## PRODUCT/PROCESS CHANGE NOTICE (PCN)

<p>PCN #: <b>A-0310-01</b>                      DATE: 10/10/2003</p> <p>Product Affected: <b>Not Applicable</b> <b>(New Product Offering)</b></p> <p>Date Effective: 10/10/2003</p>	<p>MEANS OF DISTINGUISHING CHANGED DEVICES:</p> <p><input checked="" type="checkbox"/> Product Mark     "G" character in the package code (New ordering Part # for Green Parts)</p> <p><input type="checkbox"/> Back Mark</p> <p><input type="checkbox"/> Date Code</p> <p><input type="checkbox"/> Other</p>
---	---

### ATTACHMENT - PCN #: A-0310-01

**PCN Type:** Green product offering

# IDT 260°C Reflow Profile

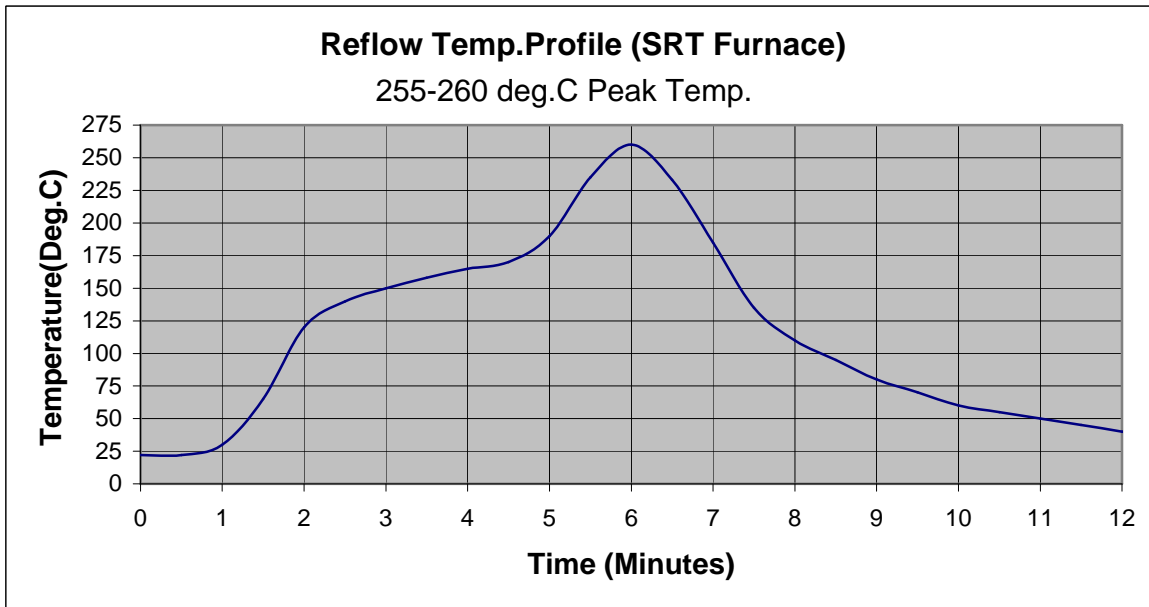
Green Parts are assembled using material sets that are selected for their superior properties and low moisture absorption. Green parts are qualified using JEDEC-Std-020B for moisture sensitivity classification with peak reflow temperature of 260°C. Please see below the recommended 260°C reflow profile. Reliability tests include Auto Clave, HAST, Temperature Cycle, Solderability, Storage tests, and tin whisker inspection.

Parameter	Value
Max. Ramp-up Rate (200°C to Peak)	3°C/second
Preheat Time (175°C ± 25°C)	60-180 seconds
Time Maintained Above 217°C	60-150 seconds
Time within 5°C of actual Peak Temp	20-40 seconds
Peak Temperature	255°C +5/-0°C
Max. Ramp-Down Rate	6°C/second
Time 25°C to Peak Temperature	8 minutes max.
